NUMBER
005

MODEL
Sportage

Technical Service Bulletin

HVAC Mode Control Switch

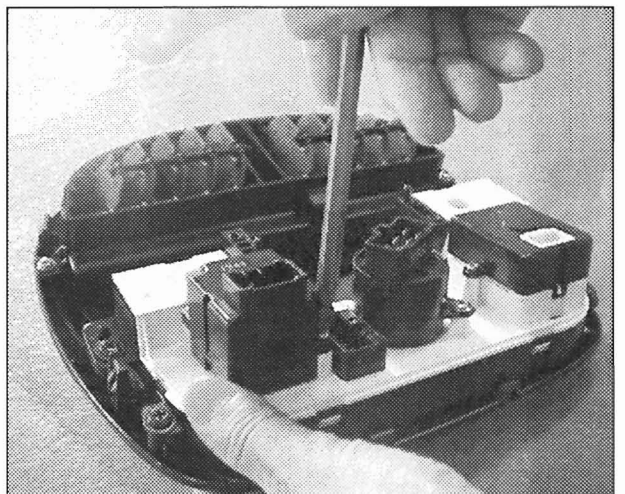
1. Open cup holder, grasp center panel assembly as illustrated in photo, and pull to release panel assembly from retaining clips.

2. Disconnect four (4) HVAC control electrical connectors and remove center panel.

3. Remove mode control switch from center panel by removing two (2) screws, and knob. Discard old switch and knob.

To correct this condition, the internal switch contact has been revised to eliminate breakage.

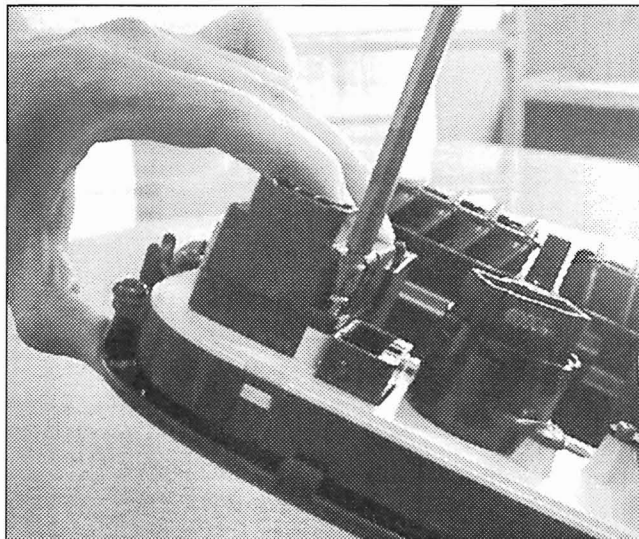
4. Install new mode control switch with the two (2) screws, then install the new knob.

5. Reconnect the four (4) HVAC electrical connectors.

6. Reinstall center panel to dash.
7. Check and confirm proper HVAC mode control operation.
